IMPORTANT SAFETY RECALL

NHTSA Recall No. 26V-006

SN735

SUBJECT: Upper Control Valve – Enable Cavity Plugs

- Figure 1 - Typical location to inspect of upper control valve enable section

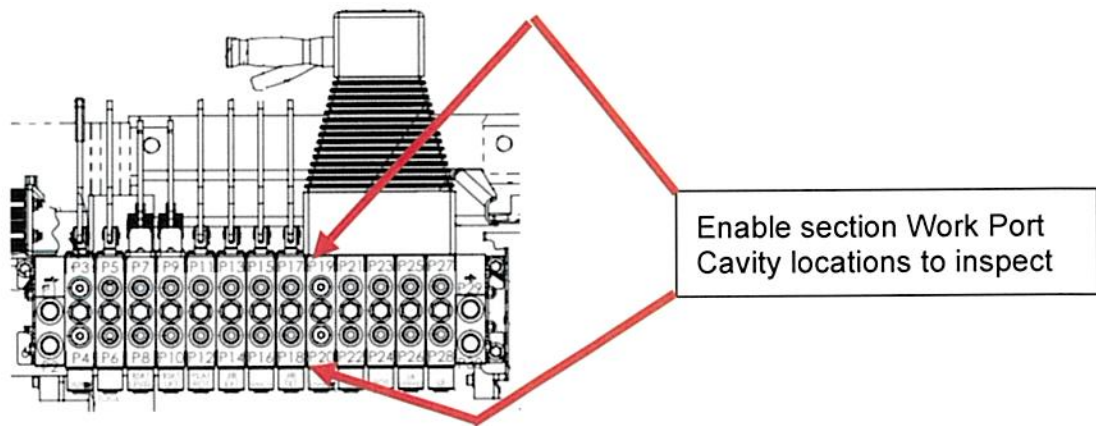
Valve assemblies 462052, 481326, 485616, and 486437 may have been assembled with No Relief (NR) plug in the enable section of the upper control valve for units built from January 1, 2025 to September 9, 2025. The plug in the enable section work port cavity should be a standard SAE O-ring plug to allow oil flow into the return passage when the enable is not engaged. The NR plugs will cause flow across the lower relief valve if upper controls are selected and the enable functions are not operated. It will also hold the engine speed on high throttle if demand throttle is installed. **Continued use will increase the oil temperature and may cause burns.**

There are three methods to determine if a unit is subject to this recall. If in doubt use method 2 to determine if the correct plug is installed in the enable section work port cavities or if Z1765 is required. Position the platform and rotate the platform out if needed, and remove covers if necessary to see the upper control valve as shown in Figure 1.

2. Position the platform where you can look at the upper control valve. Shut off the engine and relieve the pressure by depressing the STOP control at the platform. Position a pan or rags to collect oil spillage and remove the upper and lower work port cavity plugs from the enable section using a 5/16 Allen-Wrench as pointed out in figure 1. If the plug is an NR plug as shown in figure 3 replace with standard plugs as shown in figure 2.

Perform one or more of the inspections above. Refer to the pictures below for clarification. If the plug are black in color or verified by visual examination the incorrect plug is installed and must be removed and replaced with a standard SAE 10 Hollow Hex Plug, 411585 included in Z1765. Fill in the completion record included with the owner letter and return.
